## ADDENDUM NO. 3 MARKET STREET GARAGE LOWER LEVEL OFFICE UP-FIT Addendum Date: 3/28/2022

**Project: Market Street Garage Lower Level Office Up-Fit**  
**IFB#: 22-101 MARKET ST GARAGE LWR LEVEL OFFICE UP-FIT**  
**IFB Date: March 7, 2022**

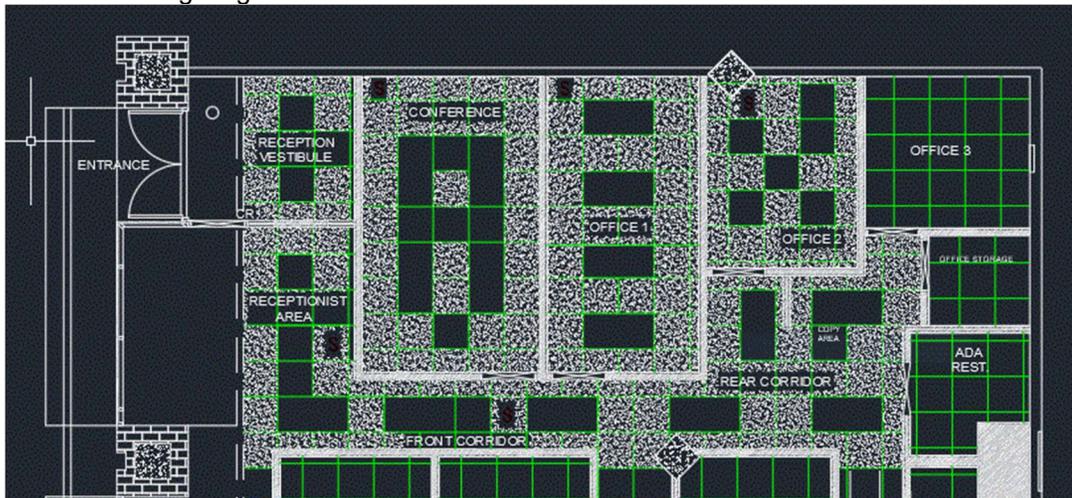
- 1. Question:** Do all corridors and hallways receive sound deadening ceiling tiles?

**Answer:** The shaded areas below illustrates all areas that will receive sound deadening ceiling tiles for the base bid. This is a revision from as the rear corridor/copy area and the reception vestibule are now included. Note: The lighting and the HVAC are not shown in the illustration.

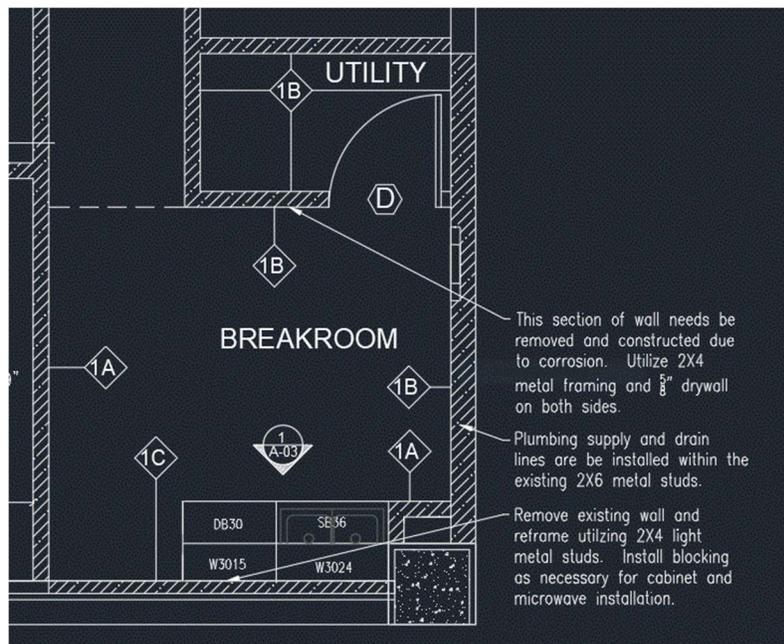
1. See Question and Answer #1 of this Addendum for additional areas that will receive Lyra sound deadening tiles. The vestibule and the rear corridor/copy areas have been added to the base bid for this project.
2. Plumbing Item P7 – Plumbing supply & drain lines are to be installed within the existing 2X6 metal studs as shown in illustration below.
3. Breakroom walls – Remove and replace walls as per the instructions shown on the illustration below.
